Addendum No. 1

CITY OF ABERDEEN ABERDEEN, MARYLAND DEPARTMENT OF PUBLIC WORKS

AWWTP Digester Gas Flare Replacement

Engineering Project No. 12563982

SECTION A14-A/A13
Scale 1/4" = 1'-0"

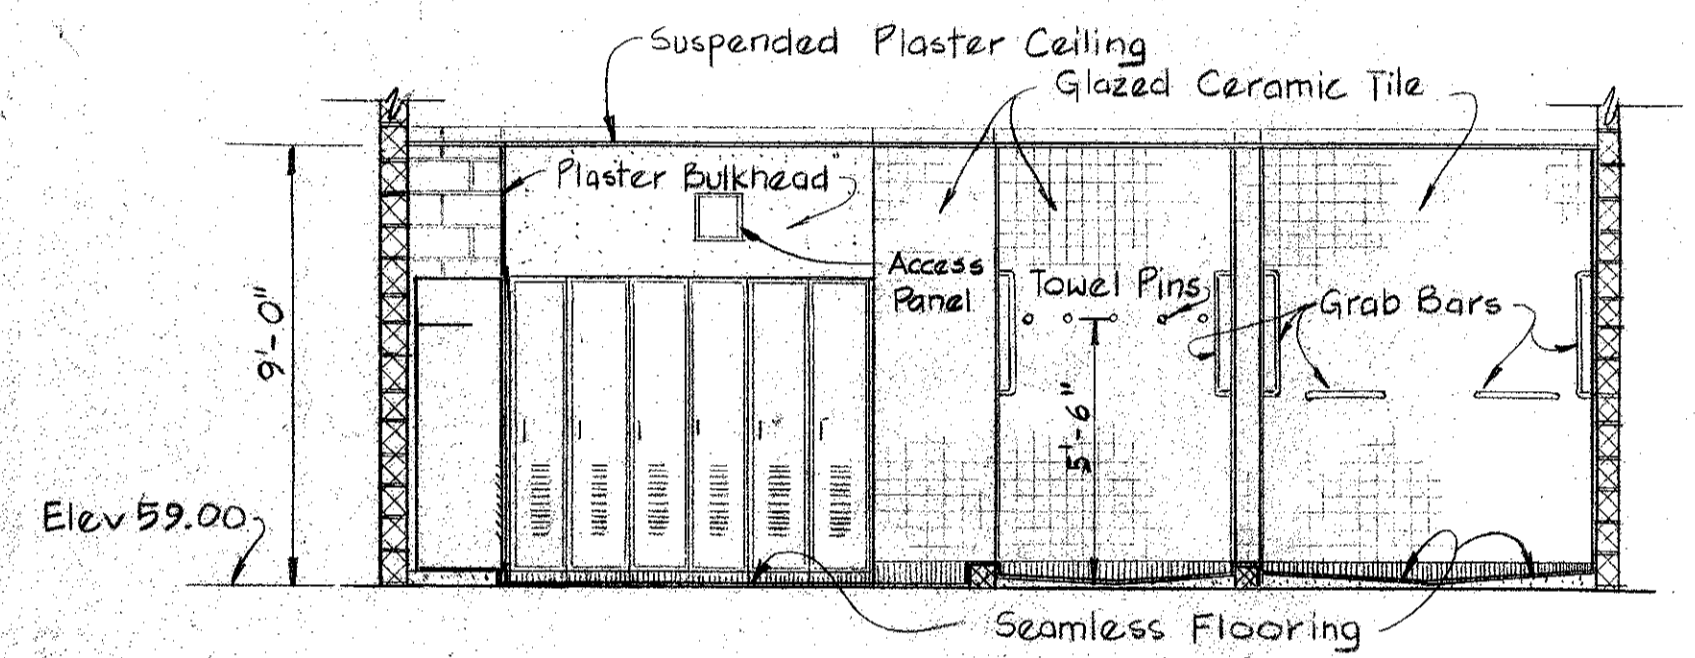
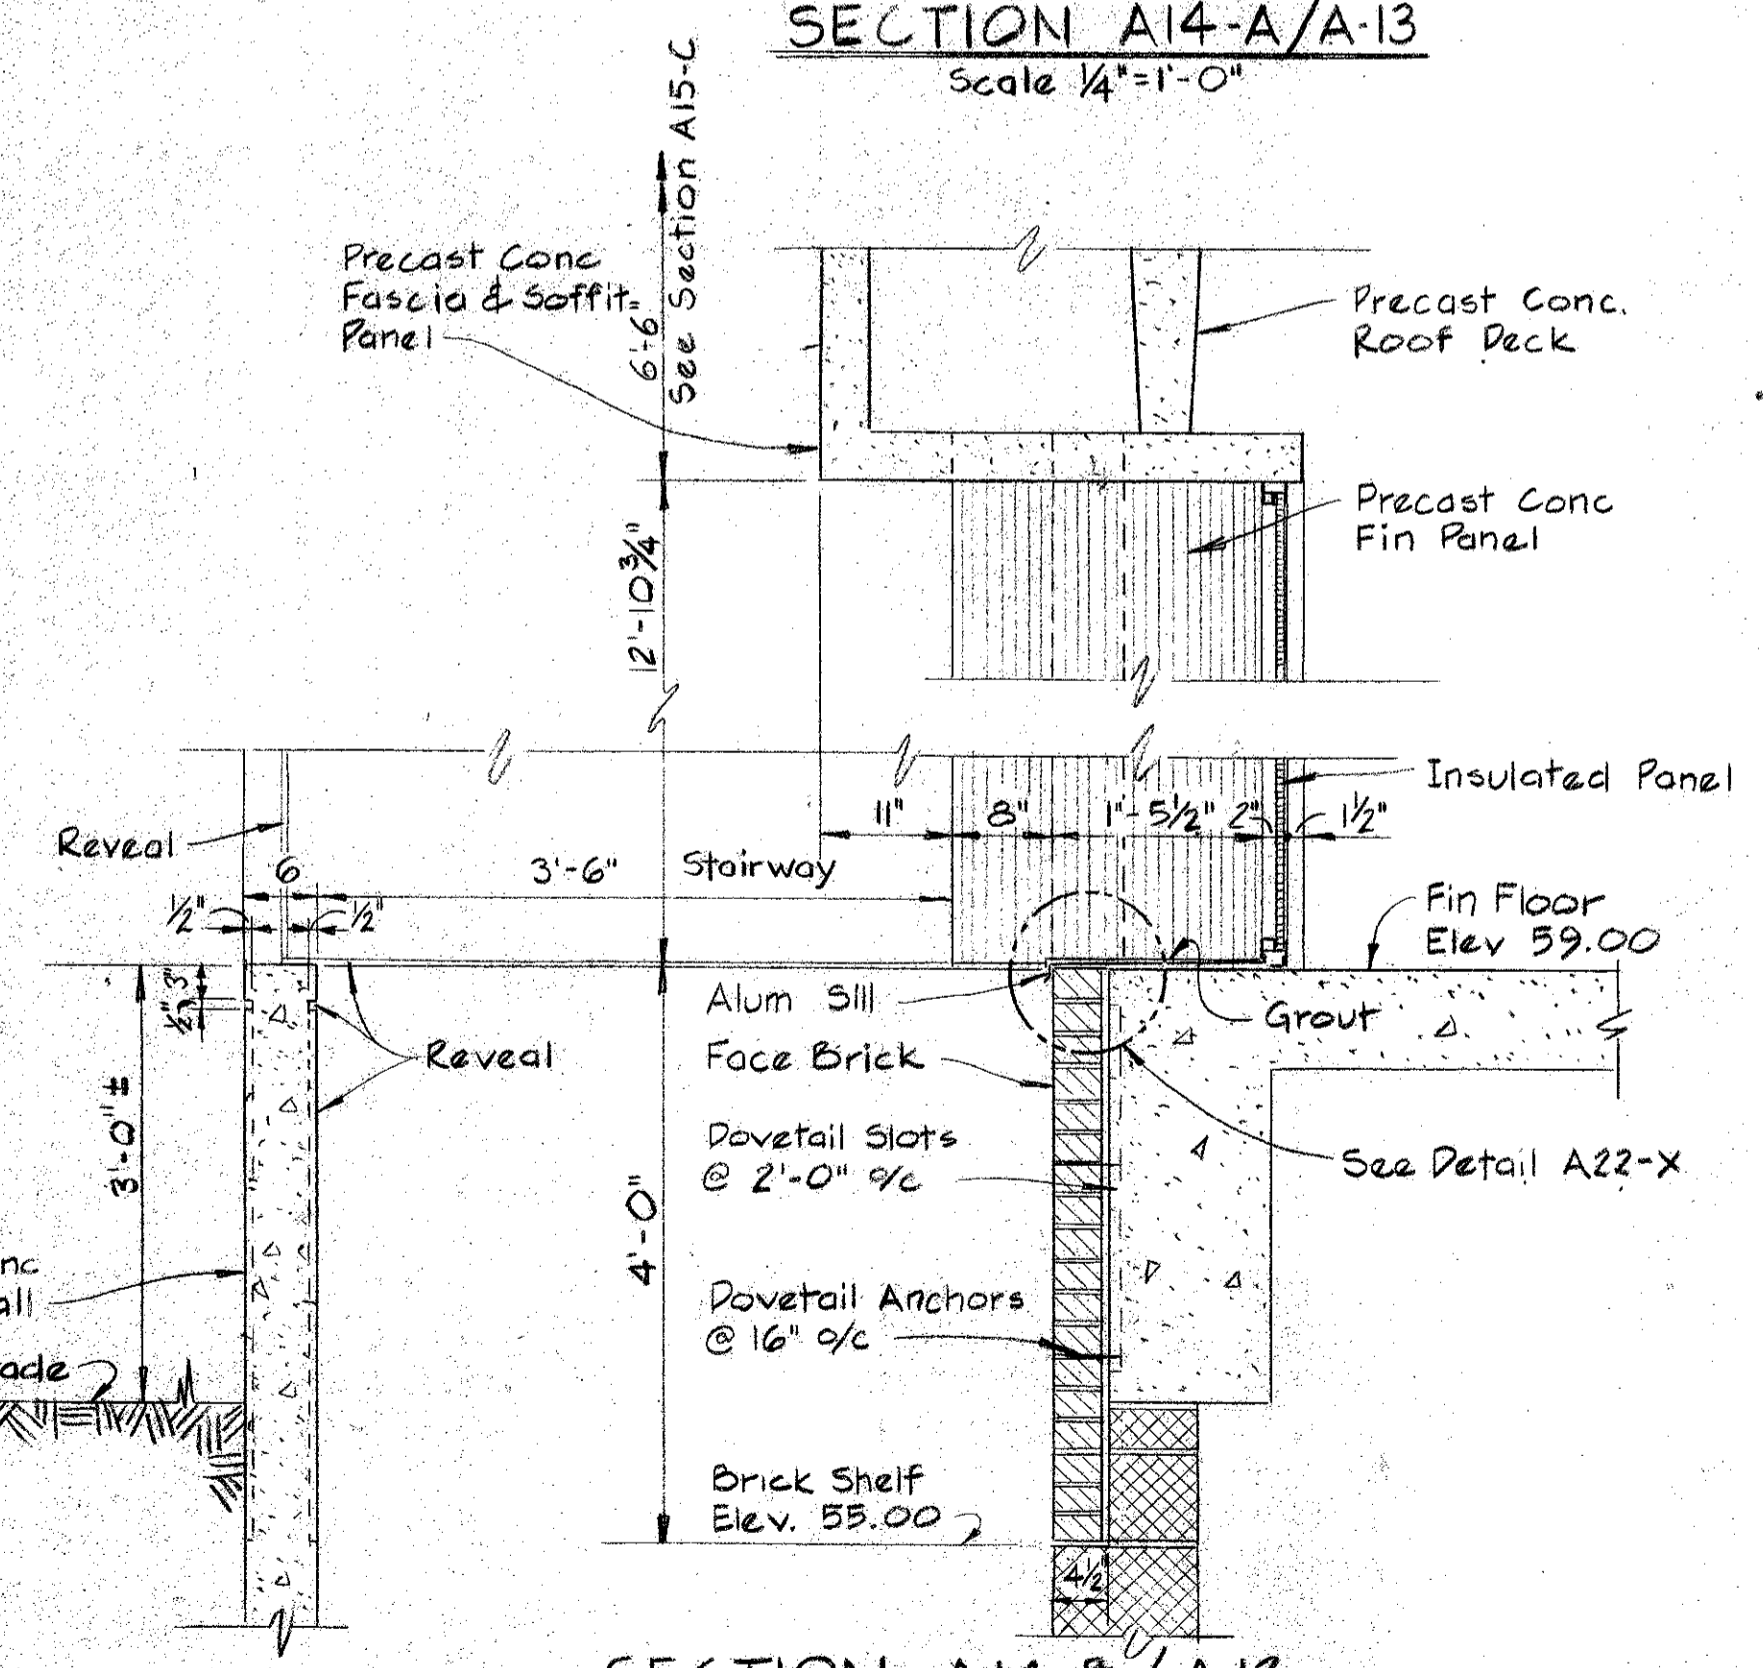
8. *Can any as-built information be provided on the existing aluminum panels that need to be fabricated to match existing on the south side of the building exterior shown on sheet 8.*

- a. The attached record drawings for bidders reference only, from the “Town of Aberdeen Advanced Wastewater Treatment Plant” Drawing No. 33 and 35 show the profile and sectional views of the Administrative Building. The panels are identified as “Insulated Aluminum Panels”
